Aquamax

750cc

PrintArea

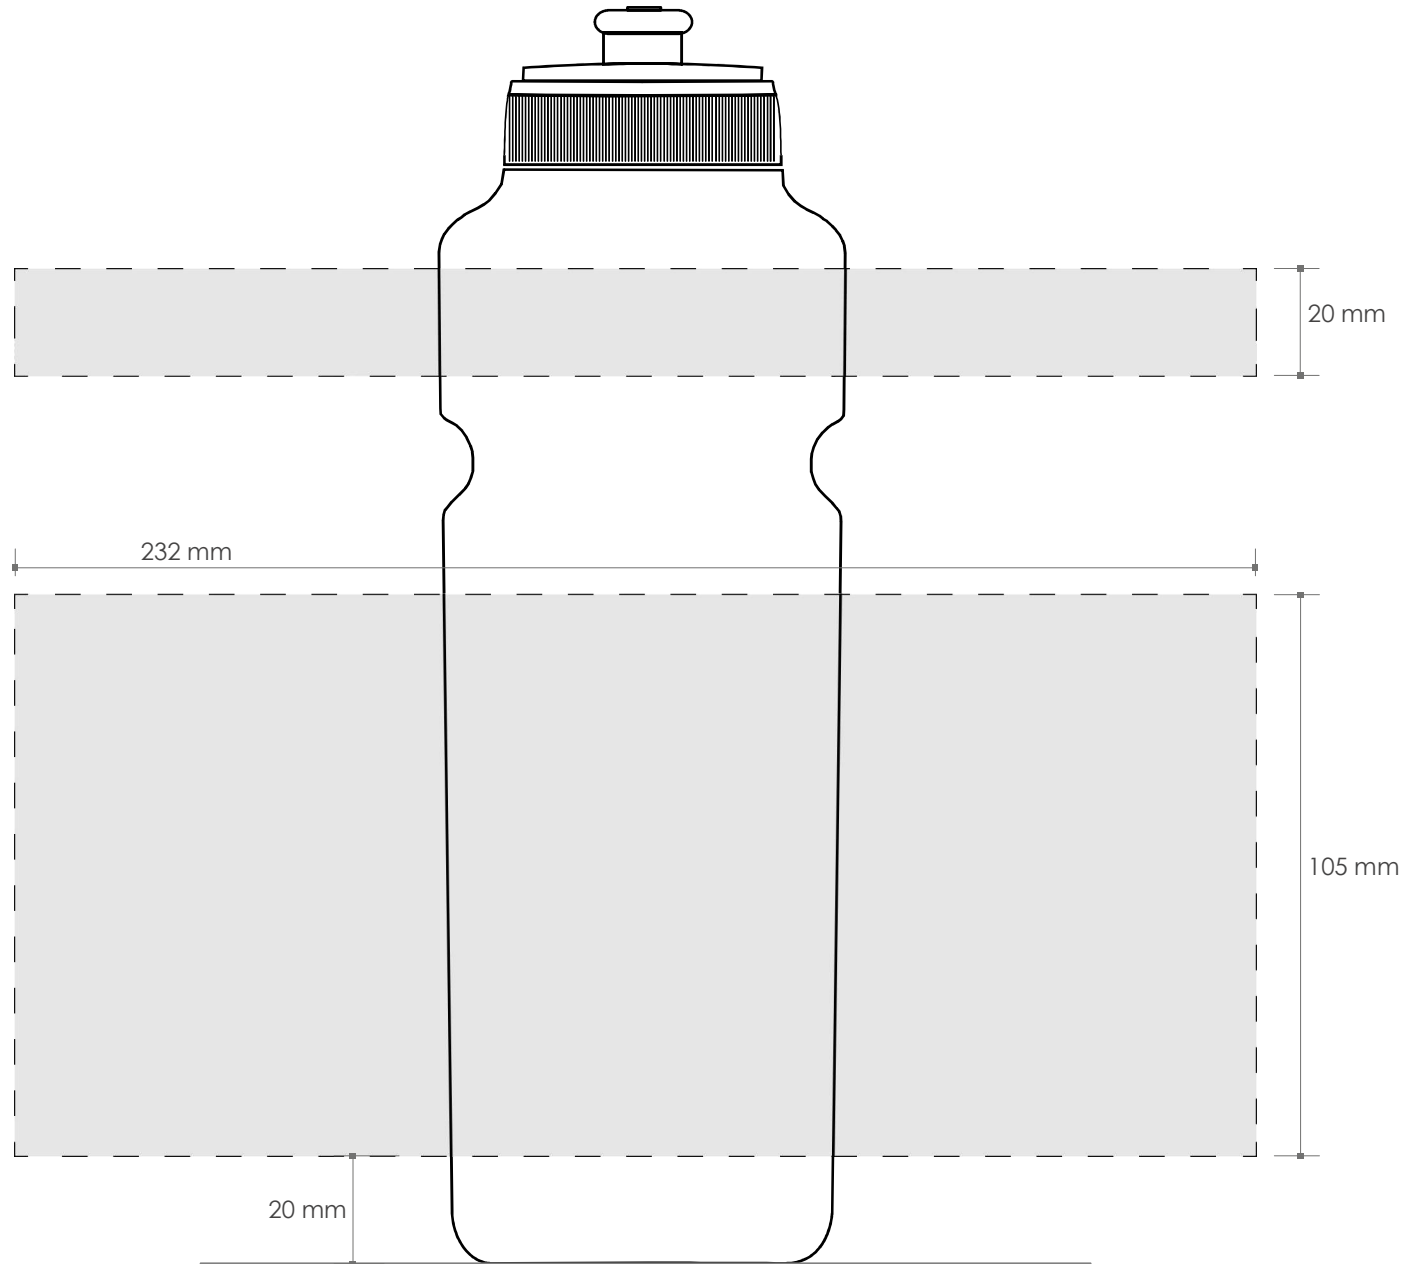
The impression can not close on the circumference of the bottle:
it's necessary to consider a non-printable area (approx. 0,8 cm width)
